REVIEW OF NOTICE OF INTENTION TO COMMENCE LARGE MINING OPERATIONS

Lime Ridge Mine
M/037/081
April 10, 2000

Re: Second Review of Notice of Intention to Commence Large Mining Operations, Holliday Construction Inc., Lime Ridge Mine, M/037/081, San Juan County, Utah

Map Attachments

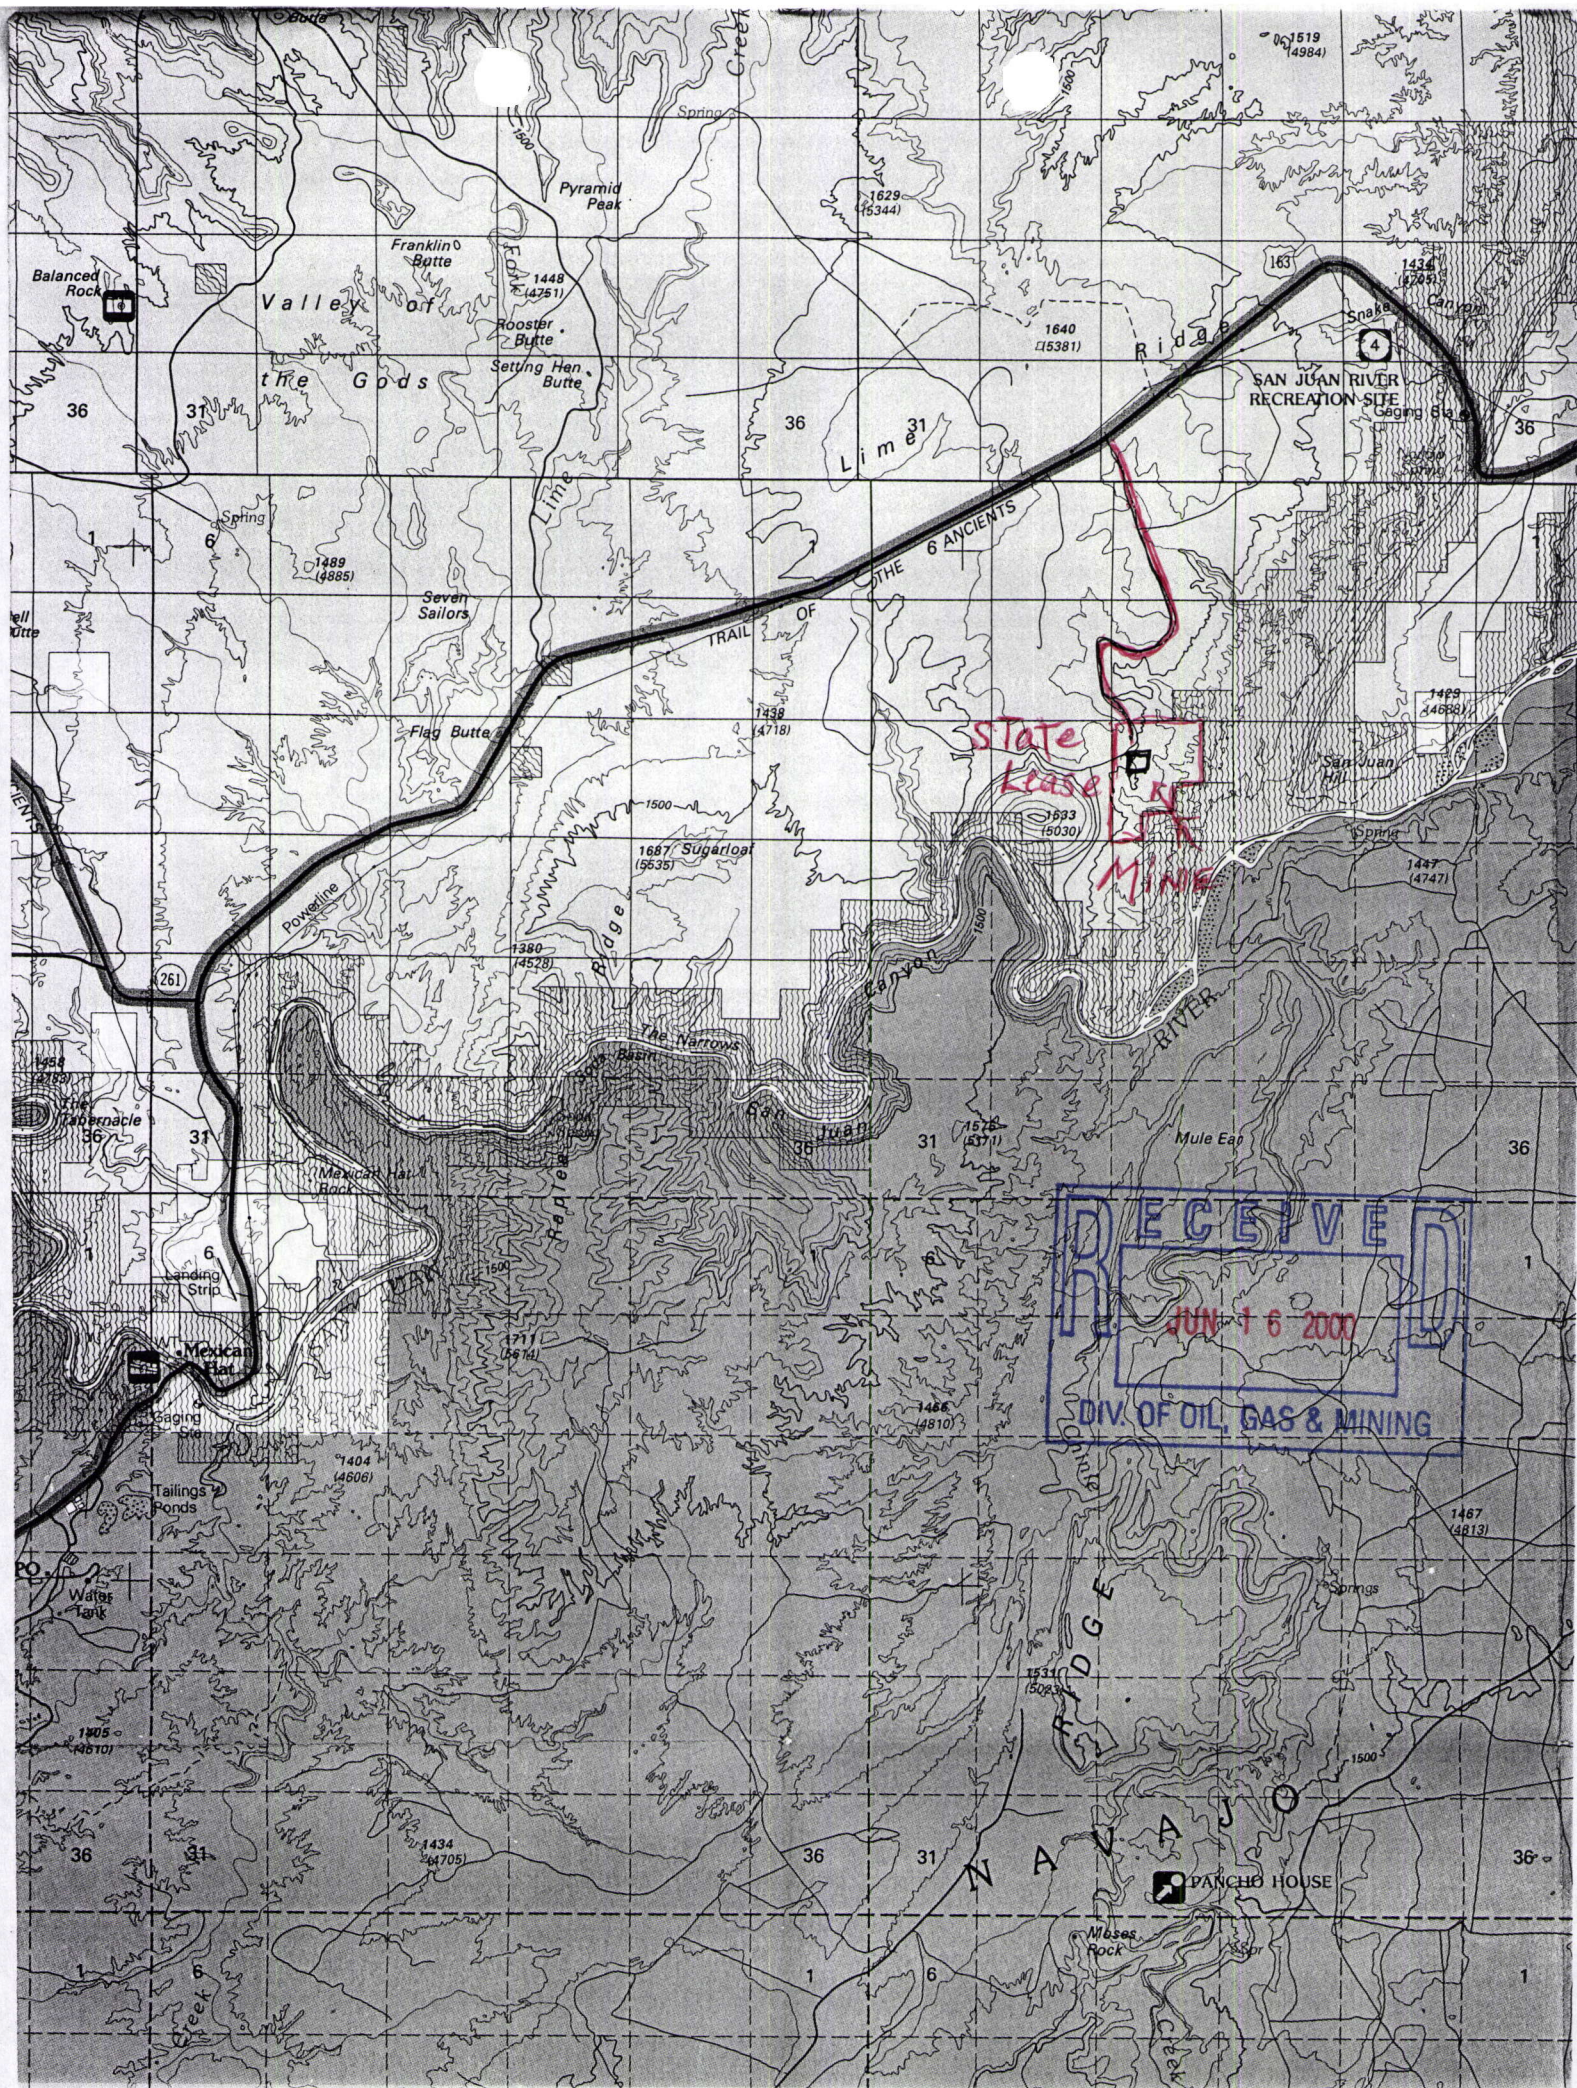
A measurement of the area impacted on the Surface Facilities Map, using the scale shown, gives approximately 2.1 acres. The impacted area described in the text of the submission is 12 new acres plus five (5) acres of existing disturbance. Surety calculations by the Division will not be possible until a scaled map of the proposed disturbance is received. Please provide a revised surface facilities map showing both the current disturbed area and the proposed disturbance. Area measurements from this revised map should agree with the acreage listed in the text of your submission. (AAG) *See attachments*

Please submit a mine plan map showing the mining sequence and projected annual disturbance for a minimum period of five years. (DJ) *See Attachments*

Please provide a reclamation treatments map which is of the same scale as the surface facilities map. Please use cross hatching or color coding on this map to identify areas receiving different reclamation treatments. (AAG) *See Attachments*

R647-4-105 - Maps, Drawings & Photographs:
105.2 See Attachments
105.3 See Attachments
